From: ELST Master Plan <ELST@kingcounty.gov>
Sent: Thursday, January 26, 2017 10:29 AM
To: reddy@benefits-consulting.com
Cc: Lindsey Ozbolt; MikeSch@msn.com
Subject: 170126 ELST South Samm B - Reddy - ROW
Attachments: 170126 ELST South Samm B - Reddy - ROW.pdf

east lake sammamish trail

RE: King County SSDP Permit-- South Sammamish Segment B
Homeowner comments regarding 60% Design Plan
Survey Station 332+00
2221 East Lake Sammamish PL SE

Subject: East Lake Sammamish Trail Expansion and Impact Questions regarding the proposed 60% plan for South Sammamish B Segment. To be included in the public record as documented concerns against the King County trial permit application.

Wall #6 Wall Profile

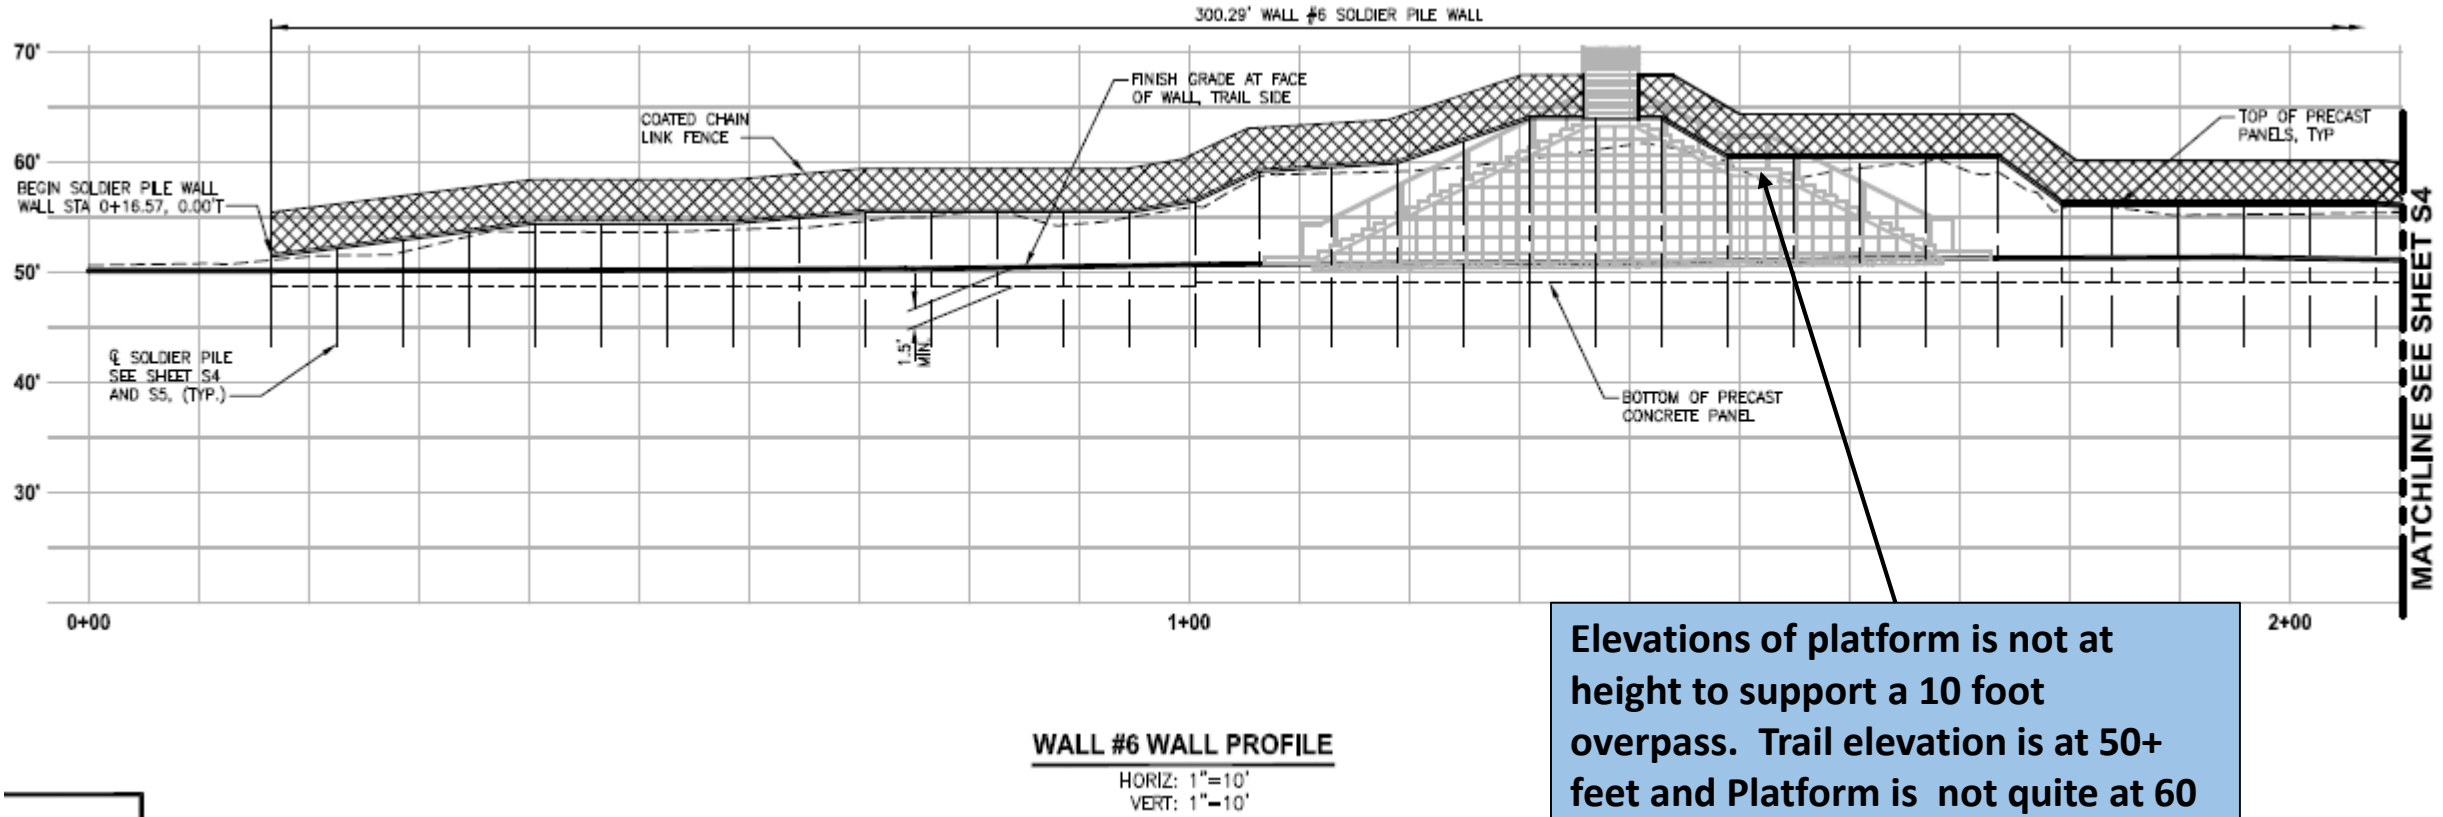
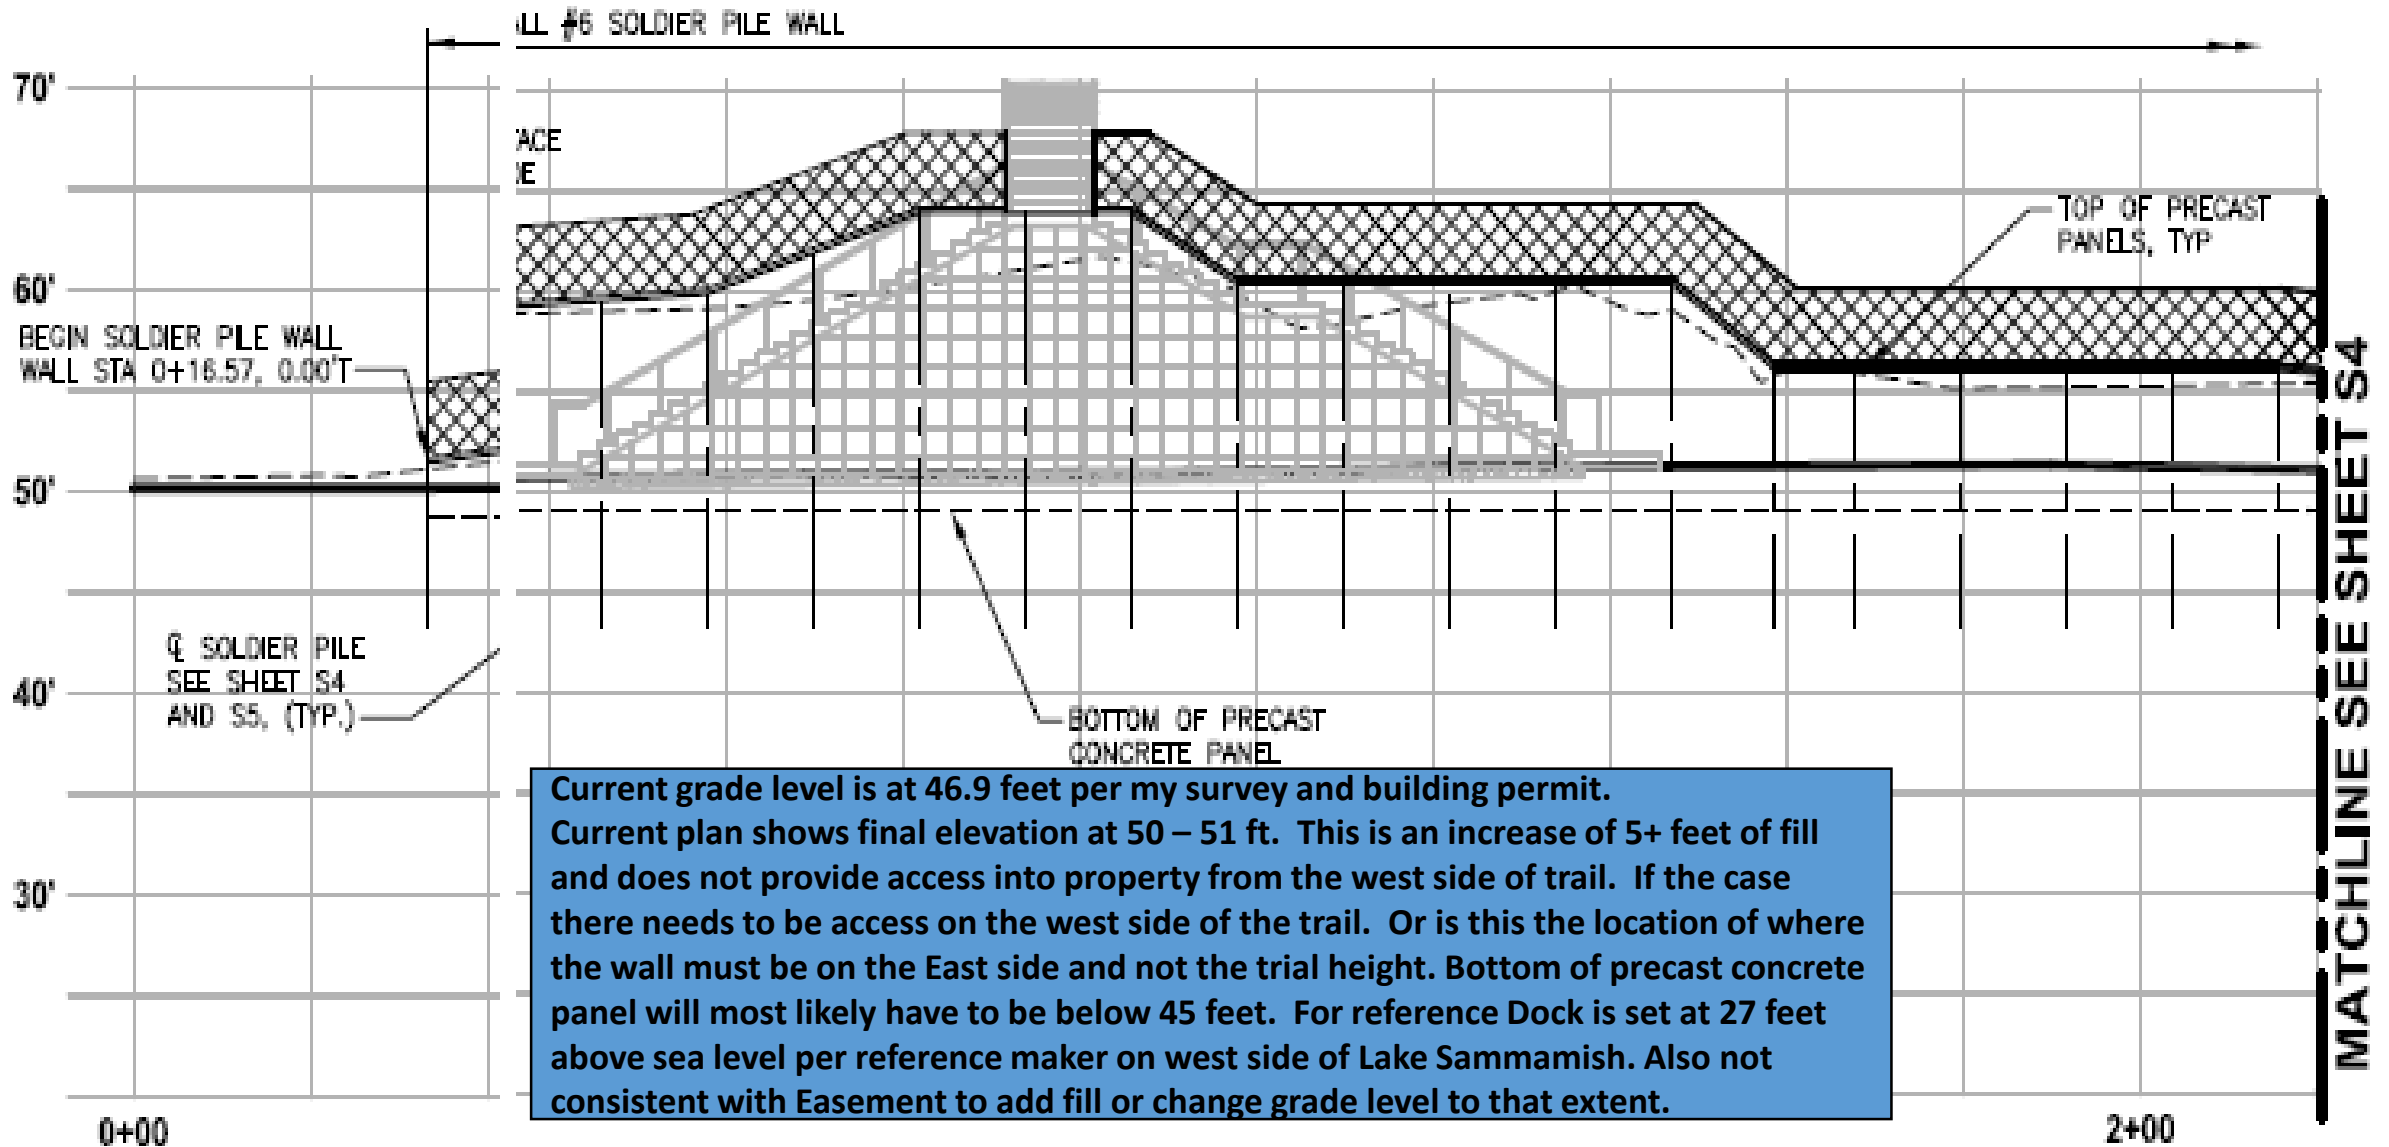
Elevations of platform is not at height to support a 10 foot overpass. Trail elevation is at 50+ feet and Platform is not quite at 60 feet. See commends on bridge requirement's and concept on slides 18, 19 and 20.

Building plans from 1999 showing land layout and the intention for a bridge over the trail.

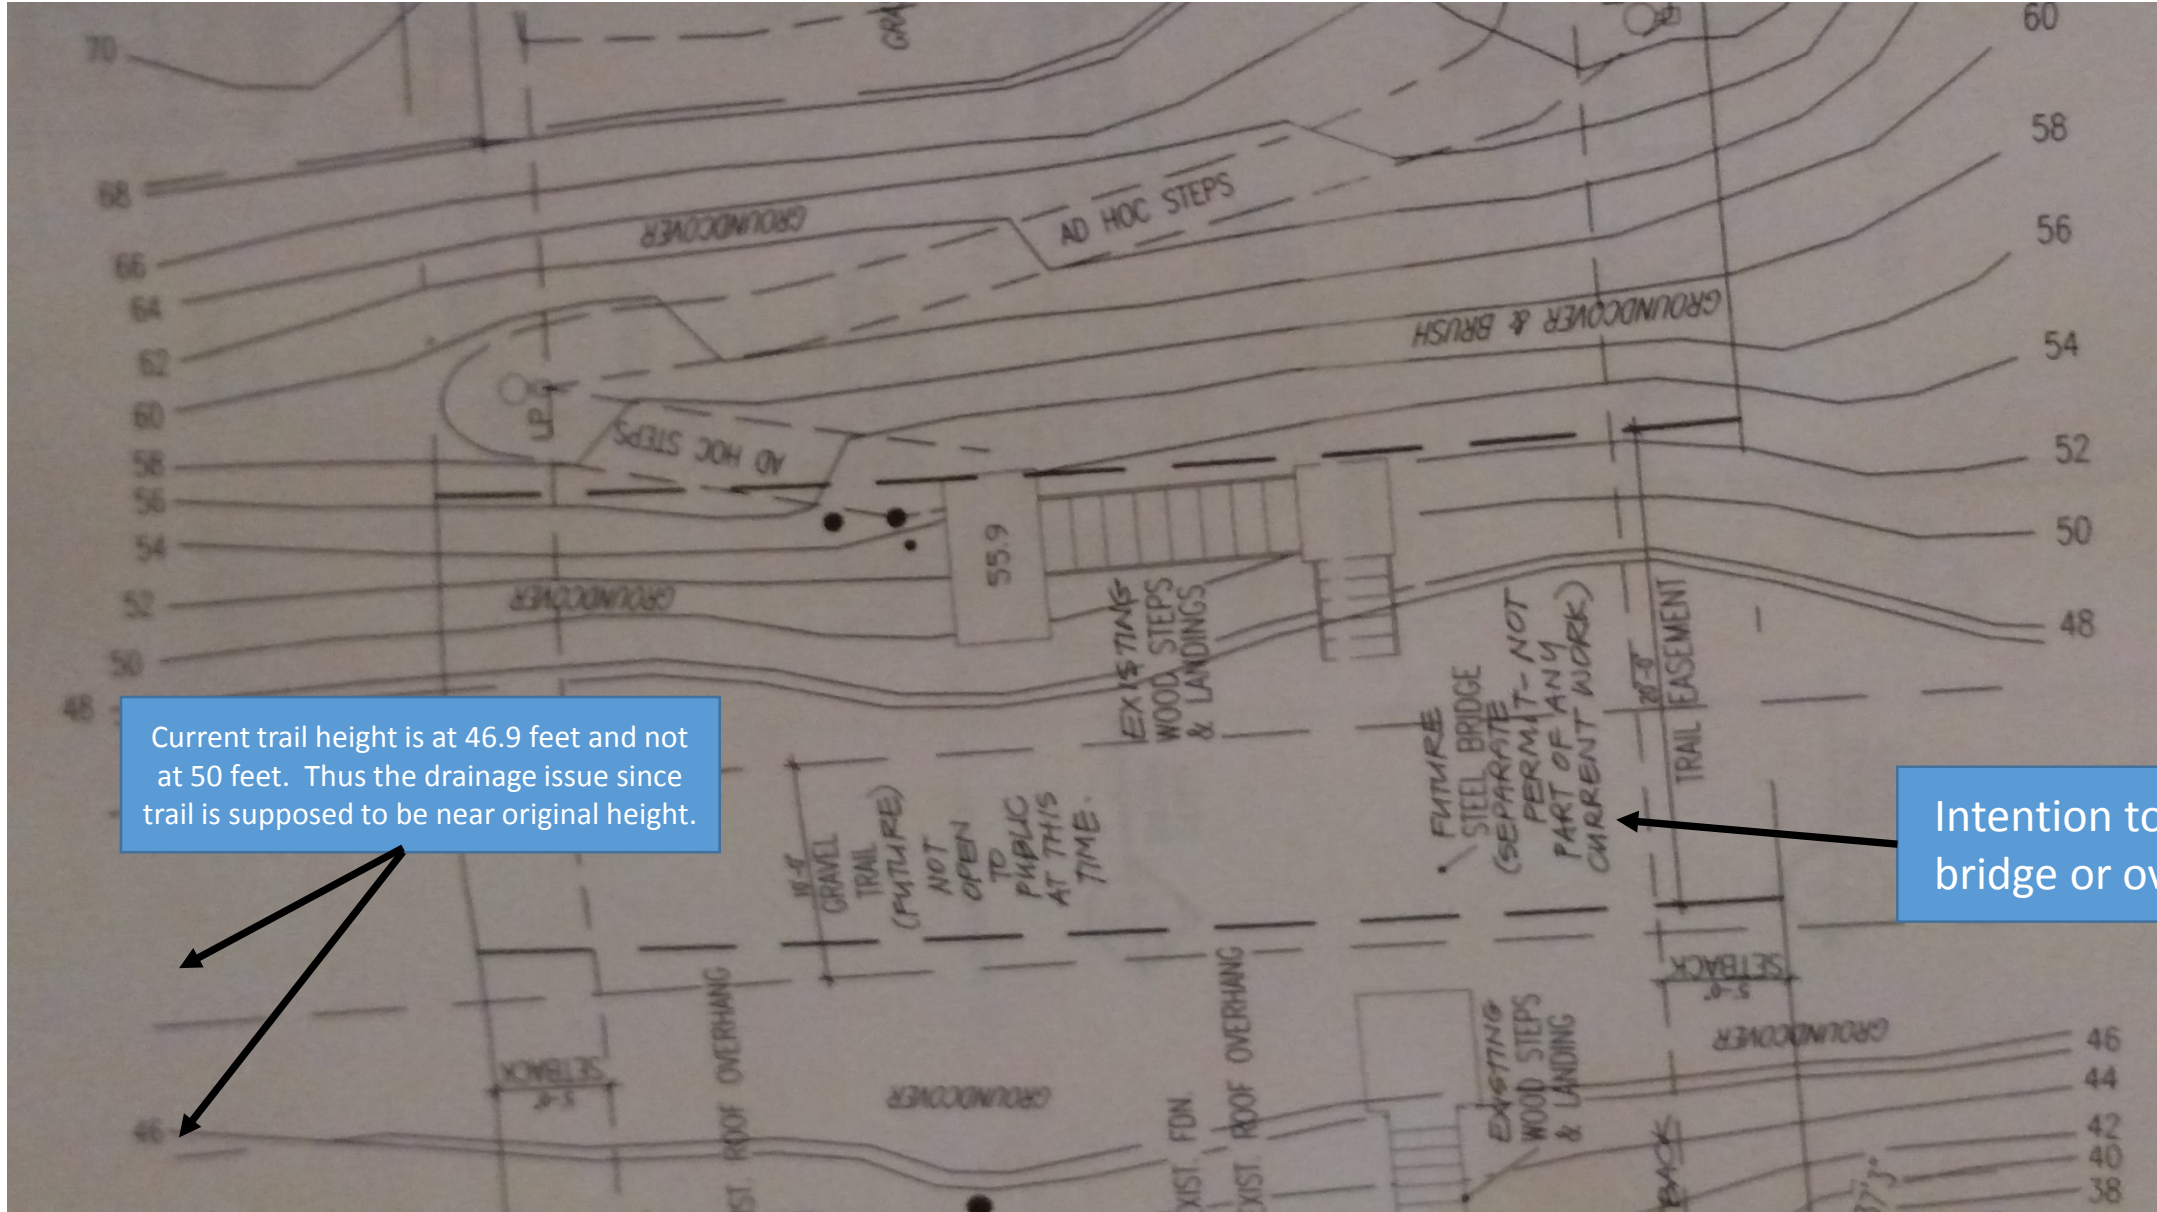
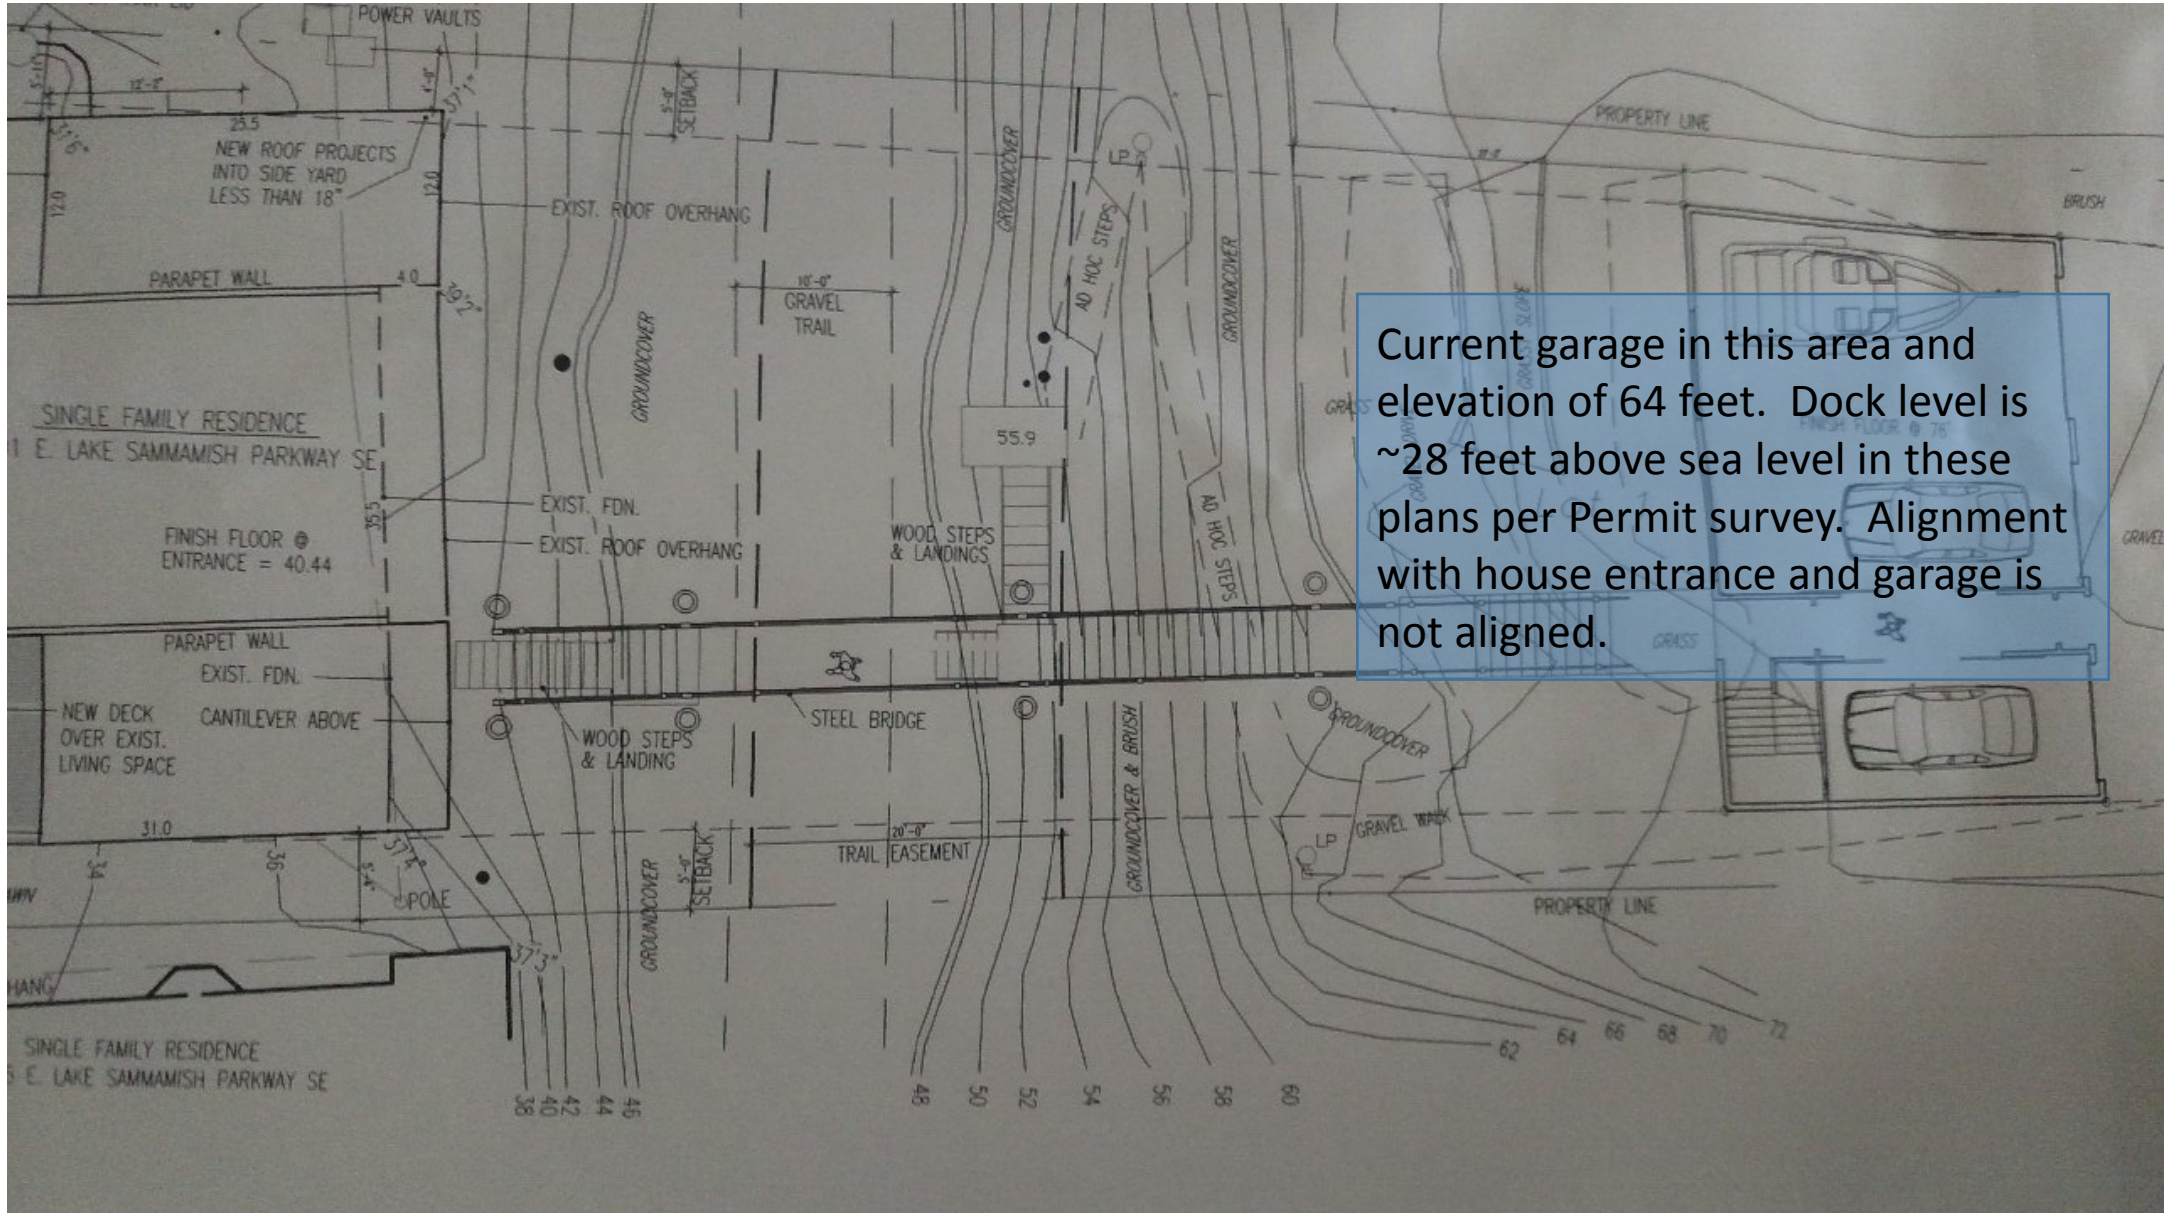
Current trail height is at 46.9 feet and not at 50 feet. Thus the drainage issue since trail is supposed to be near original height.

Intention to build a bridge or overpass.

Building plans from 1999 showing land layout and the intention for a bridge over the trail. Garage ended up being at the lower elevation of 64 ft. and not 70 feet as indicated in plans.
